COLORADO AVENUE STREET IMPROVEMENTS

COLORADO AVENUE STREET IMPROVEMENTS
VAN BUREN BLVD. TO JACKSON ST.

DESIGNED BY	CS	DRAWN BY	CS	CHECKED BY	EL
REVISIONS	REVISED PER ADDENDUM NO. 1				
MARK		APPR.	DATE

DESIGNED BY	CS	DR	WY	CS	CHECKED BY	EL
APPROVED BY	BY	DATE				
SURVEYOR						
STREET SERVICES						
CONSTRUCTION ADMIN.						
ENGINEERING MANAGER						
REVISIONS	REVISED PER ADDENDUM NO. 1					
MARK	EL 11/3/09					
APPR	DATE

NOTES:

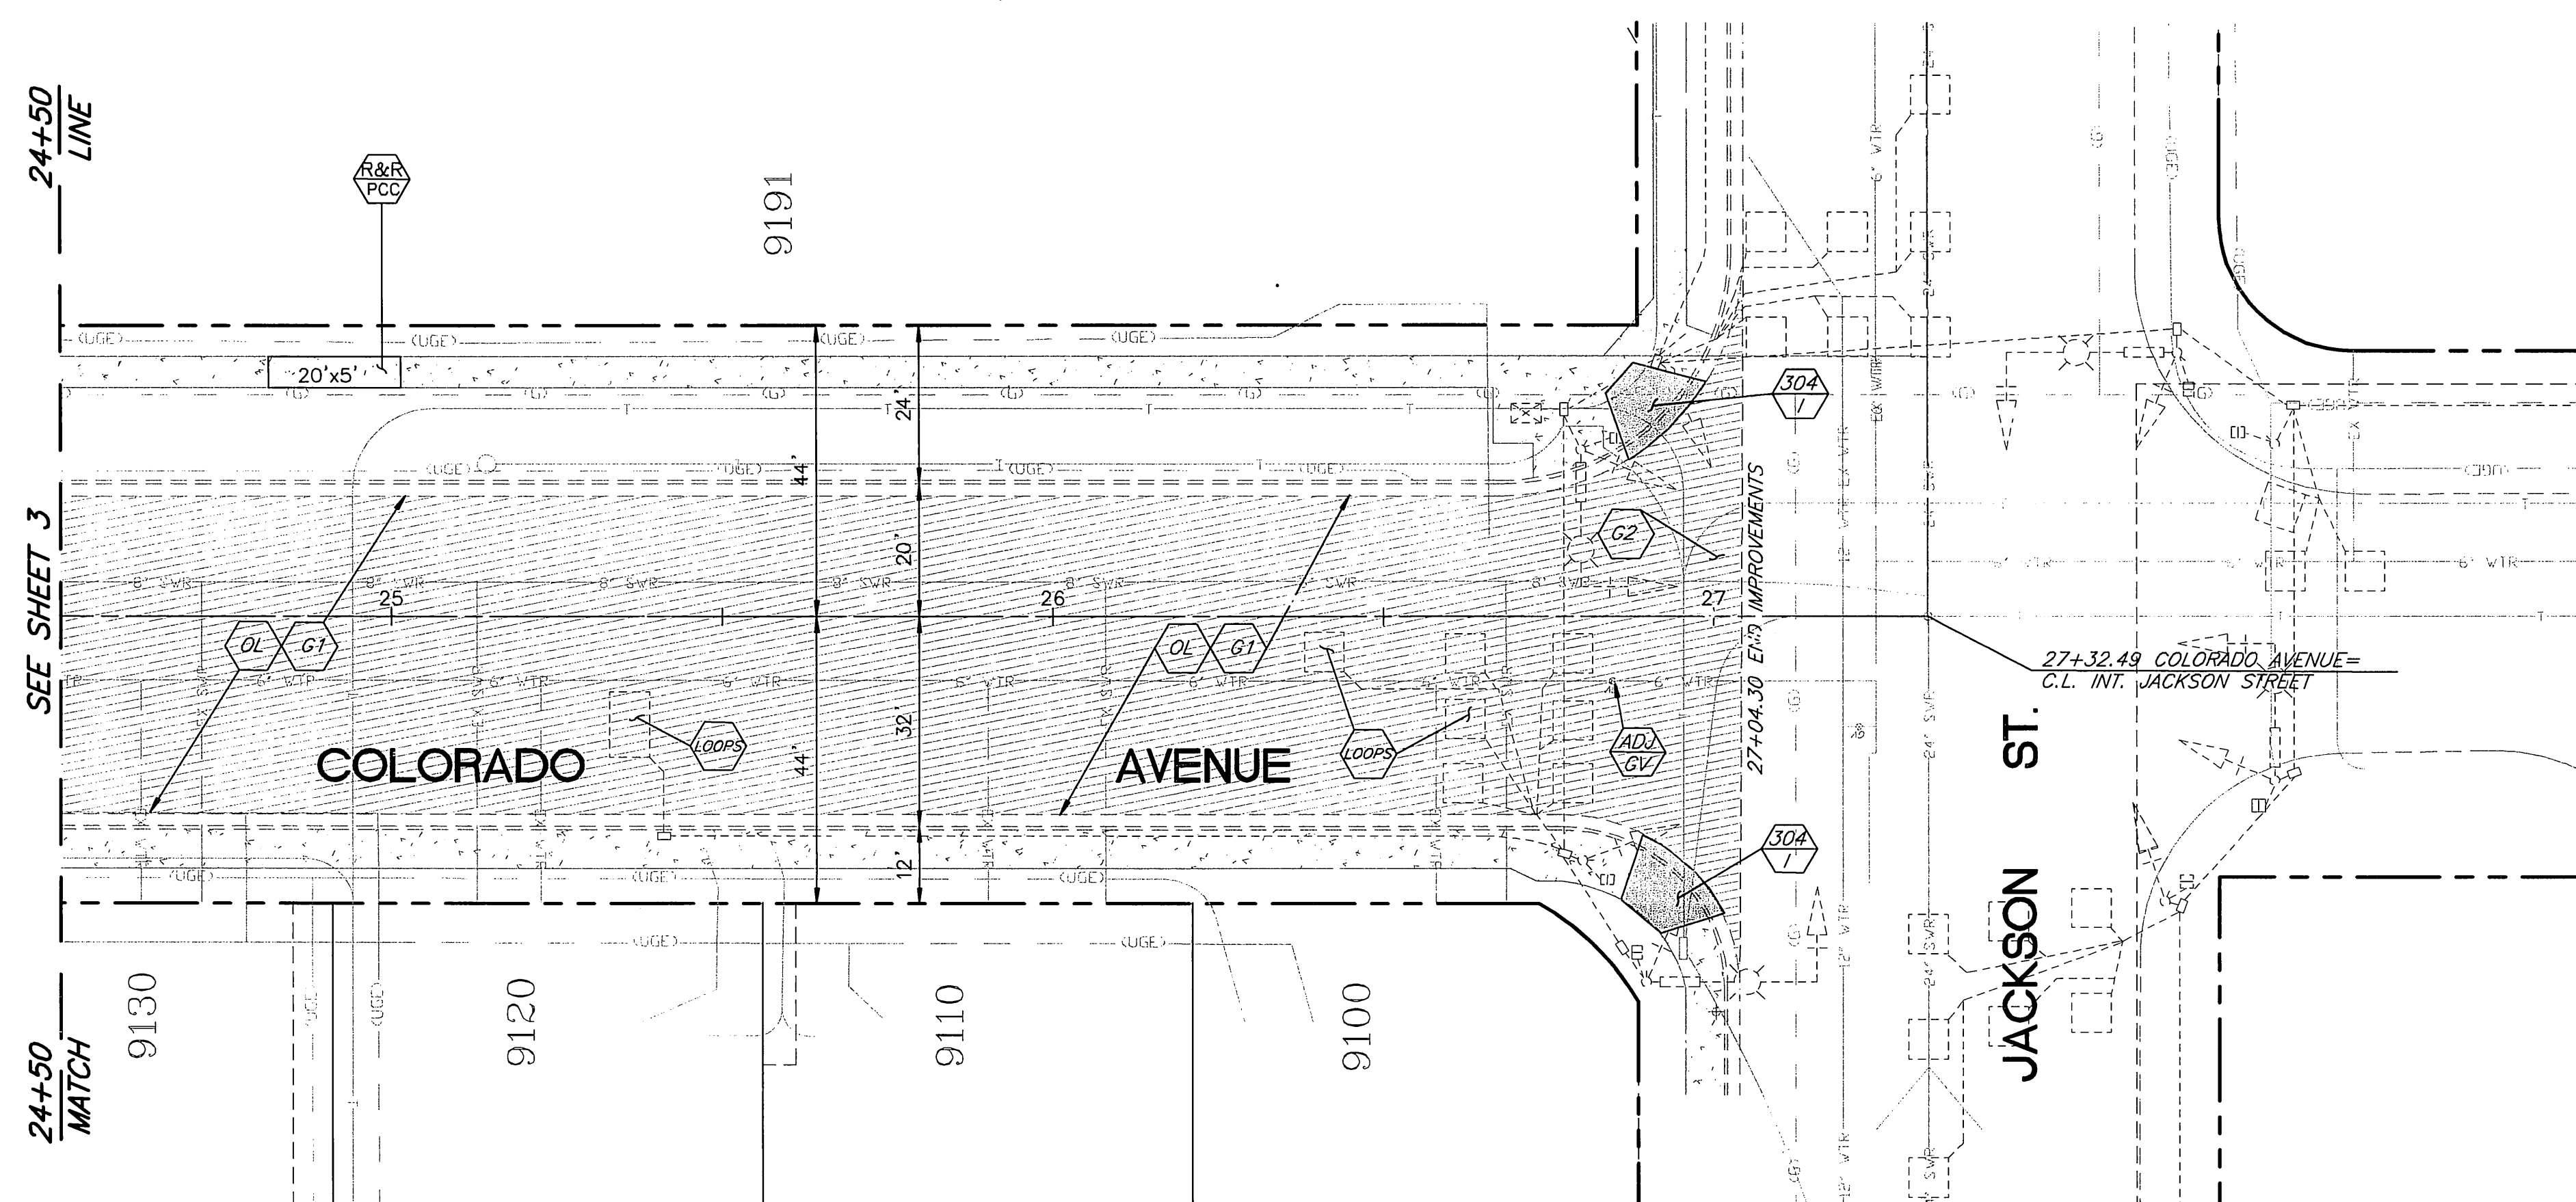
SUPERSEDED
